CERTIFICATE OF APPROPRIATENESS

**RE: Application Number 20-6983; 447 Henry; Cass-Henry Historic District
Project Scope: Rehabilitate Commercial Storefront Building**

RE: 447 Henry Street—William B. Ralston garage

Sheet
3A101

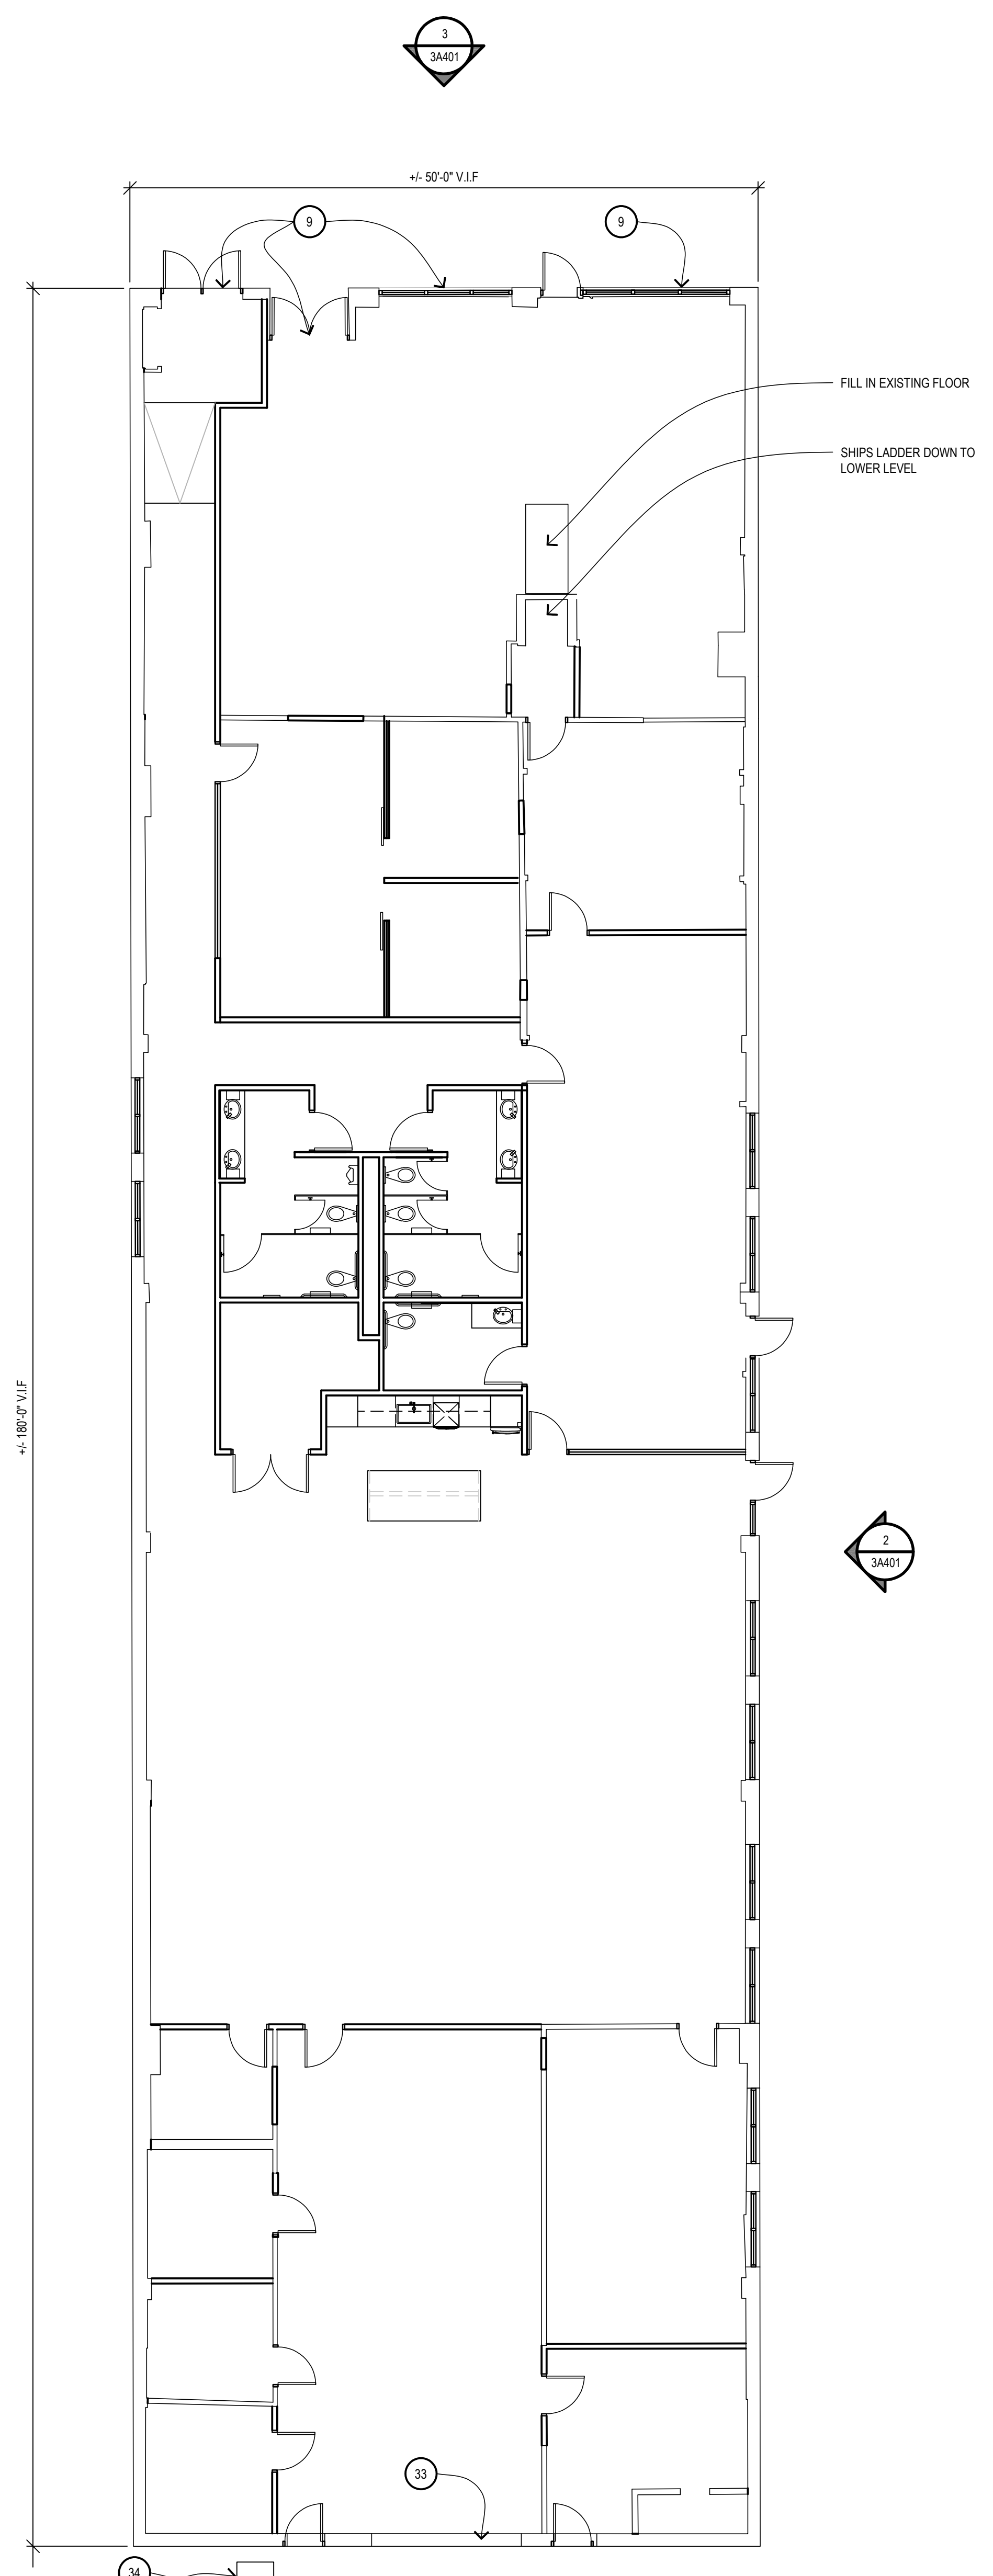
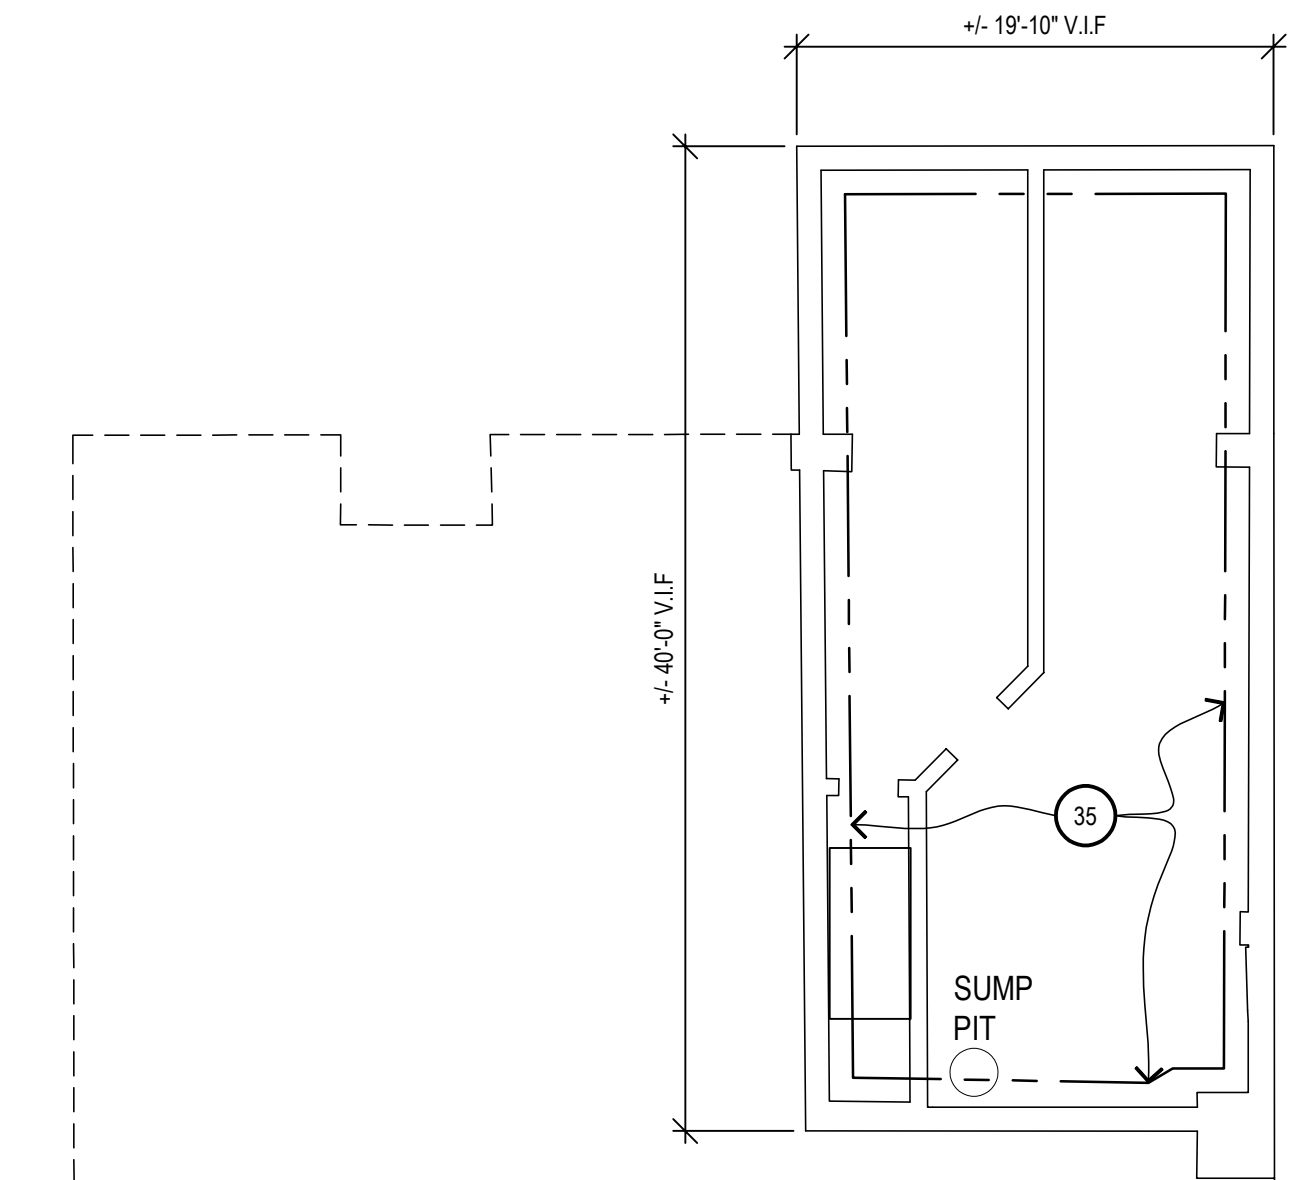
<u>Sheets</u>	<u>Revisions</u>
3A101	Added Second Means of Egress in assembly area. Placed door in existing window opening.
2A401	Added Keynote 37 – “New Cornices, Reference Adjacent Building as Basis of Design”
2A401.1	Replace all instances of “Crown Molding” with “Cornice”
3A401	Added new door location on drawing 2/3A401 based on Sheet 3A101 Location
3A401.1	Revised rendered elevations based on Sheet 3A401
4A401.1	Replace all instances of “Crown Molding” with “Cornice”
5A401	Revised Bay-Window sizes based on site measurements Added keynote 37 – “New Cornices, Reference Adjacent Building as Basis of Design”
5A401.1	Revised rendered elevations based on Sheet 5A401 Replace all instances of “Crown Molding” with “Cornice”
5A421	Revised Bay-Window sizes based on site measurements
